Errata Sheet

AASHTO/AWS D1.5M/D1.5:2008, *Bridge Welding Code*

Figure C-3.5—Illustration of Camber Tolerances for Steel Beams

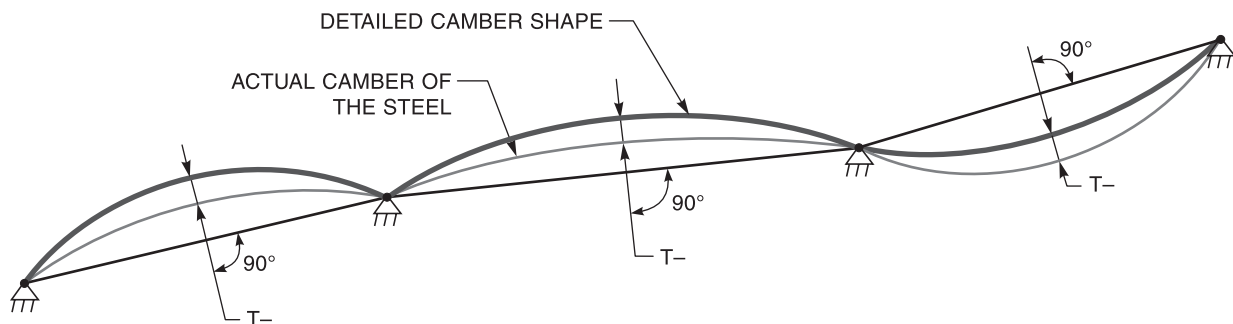
Page 319—Figure C-3.5 (A) & (B) Illustration of Camber Tolerances for Steel Beams—For sketches (A) & (B) the line depicting the “Detailed Camber Shape” was corrected and made bolder than the line depicting “Actual Camber of the Steel” for additional clarity. Please see corrected figure below:

PLUS CAMBER TOLERANCE (T_+) APPLIES WHEN THE ACTUAL CAMBER OF THE STEEL IS ABOVE THE DETAILED CAMBER SHAPE. THIS TOLERANCE IS MEASURED PERPENDICULAR TO A STRAIGHT LINE BETWEEN THE SUPPORTS OF EACH SPAN.

MINUS CAMBER TOLERANCE (T_-) APPLIES WHEN THE ACTUAL CAMBER OF THE STEEL IS BELOW THE DETAILED CAMBER SHAPE. THIS TOLERANCE IS MEASURED PERPENDICULAR TO A STRAIGHT LINE BETWEEN THE SUPPORTS OF EACH SPAN.
